Re: Council File 19-1077
1140 S Broadway
Response to Appeal ENV-2018-3289-CE-1A
PLUM Committee Hearing Date: February 11, 2020 – Item No. 6

Subject: 1138–1140 Broadway Hotel – Response to Loeb & Loeb LLP Letter

CASE NO. ZA-2018-3288-CUB-SPR
LETTER OF SUBSTANTIAL CONFORMANCE
1140 South Broadway (1138-1142 South
Broadway)
Central City Planning Area
Zone : C2-4D-O-SN
C.D. : 14 – Huizar
D.M. : 126A209
CEQA : ENV-2018-3289-CE
Legal Description: Lots 28 and 29, Tract 2289

FLOOR PLAN LEVEL 01

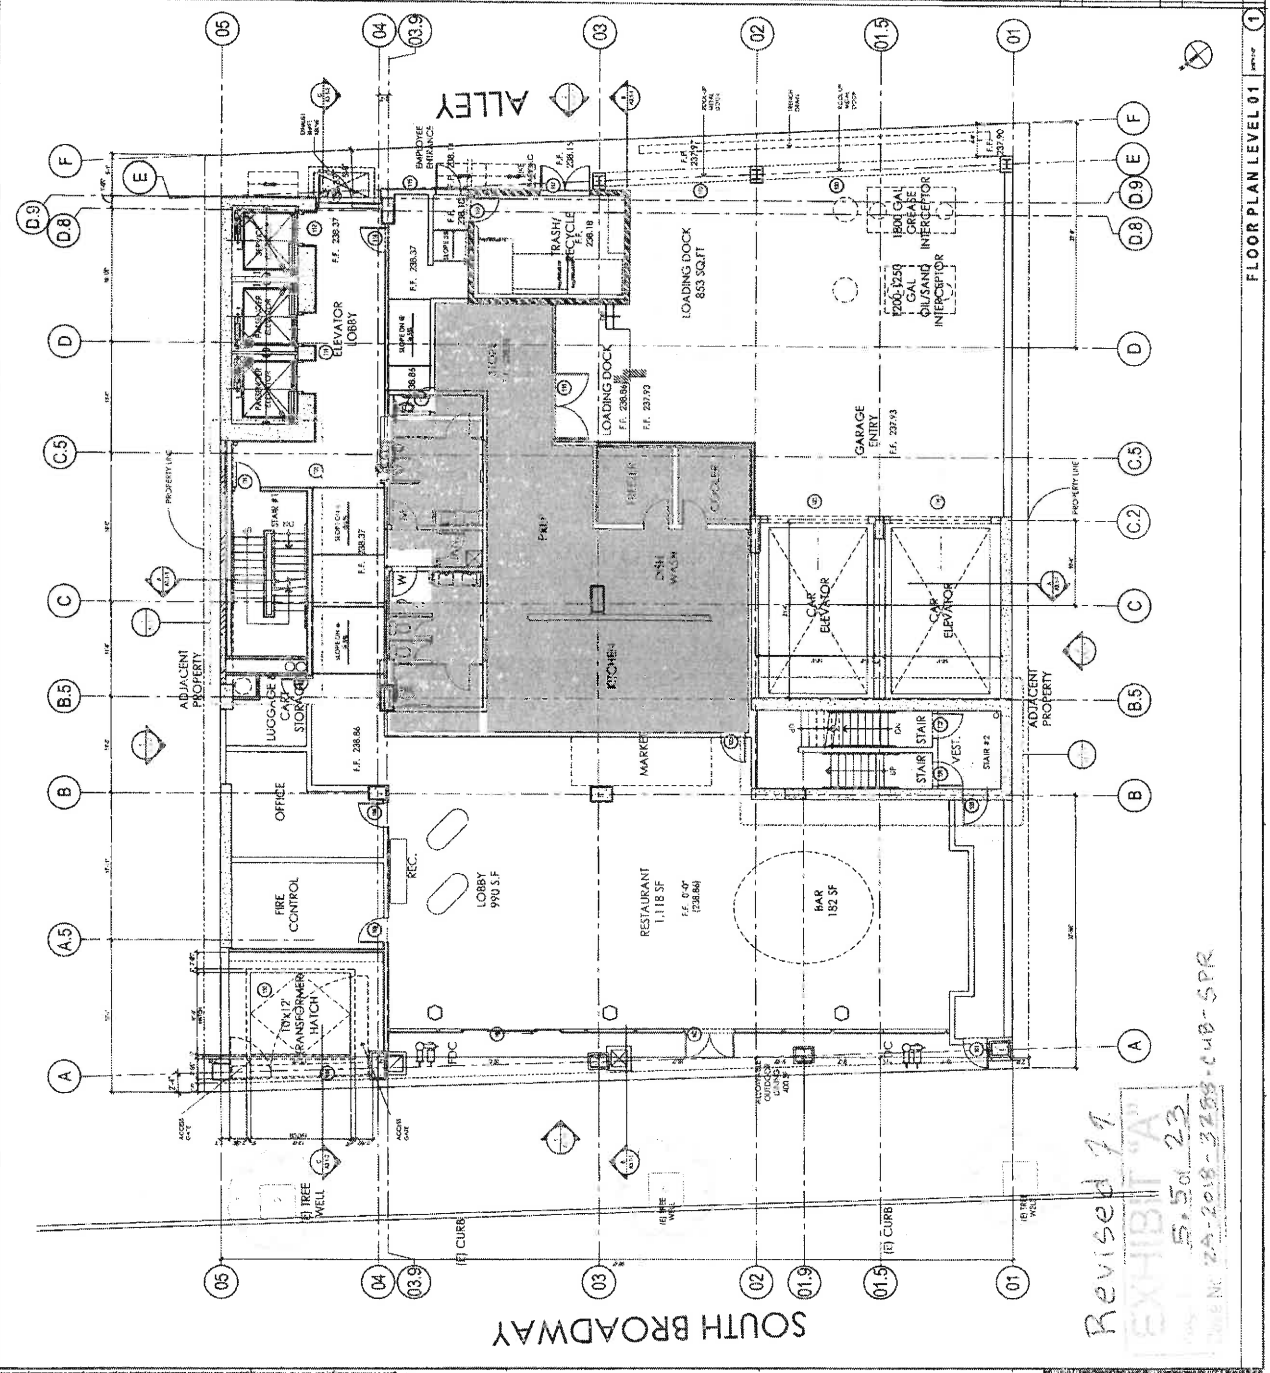
minor revision to the plans are still in substantial conformance to the previously approved set of plans stamped Exhibit 'A'. The applicant submitted updated floor plan (Sheet 7) and updated building sections (Sheet A3.1-1) depicting the rear yard setback.

A review of the revised plans show that the building envelope and height are essentially the same as the approved plans. While the ground floor will now provide a setback along the rear property line, the second through fourth levels remain unchanged and will cantilever over the ground floor setback to the property line consistent with the approved plans. The updated building section shows a 20' high clearance is provided from the ground to the second floor along the rear setback to accommodate adequate clearance for commercial vehicles within the alley. The location of the tower remains the same and all design elements and design features remain unchanged. No changes or modifications are requested to any of the conditions of the grant.

The Zoning Administrator finds that the revised plans remain in substantial conformance to the original approved plans stamped Exhibit 'A' and attached to the Zoning Administrator's May 23, 2019 determination (which consisted of 23 sheets). The attached floor plan stamped "Revised Exhibit A" and number Page 5.5 of 23 shall supersede and replace Page 5 of 23 of the original approved Exhibit 'A' and the attached building sections stamped "Revised Exhibit A" are hereby added as Page 16.5 of 23 of previously approved Exhibit A.
